HISTORIC AND DESIGN REVIEW COMMISSION

Agenda Item No: 32

HDRC CASE NO: 2015-372
ADDRESS: 223 QUENTIN DR
LEGAL DESCRIPTION: NCB 8411 BLK 6 LOT 64 AT 223 QUENTIN DR
ZONING: R6 H
CITY COUNCIL DIST.: 7
DISTRICT: Monticello Park Historic District
APPLICANT: Robert Webber
OWNER: Robert Webber
TYPE OF WORK: Approval of front door replacement
REQUEST:

Front Door
↓

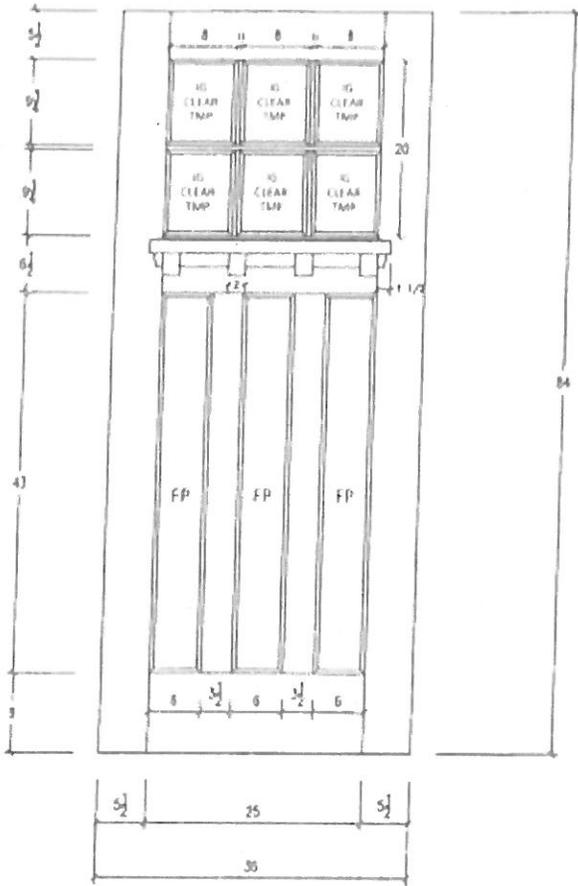
- a. The applicant has proposed to replace the existing front door of the house located at 223 Quentin with a craftsman style door. Based on the Guidelines for Exterior Maintenance and Alterations 6.A.ii. historic doors should be preserved including hardware, fanlights, sidelights, pilasters, and entablatures. Judging by photographs provided by the applicant the door appears to be original to the house and is in repairable condition. Repair would be consistent with the Guidelines.

- b. The Guidelines for Exterior Maintenance and Alterations 6.B.i. states that the replacement of doors and hardware should be in-kind when possible and only when they are deteriorated beyond repair. When in-kind replacement is not feasible, ensure features match the size, material, and profile of the historic element. The house at 223 Quentin is an example of modern architecture and post-dates the craftsman period. A craftsman style door would not be consistent with the Guidelines should replacement be necessary.

Staff does not recommend approval based on findings a and b. Staff recommends that the door be repaired. Should the door require replacement staff recommends that the applicant provide detailed information regarding the replacement door, and any new door should be in-kind with the existing door.
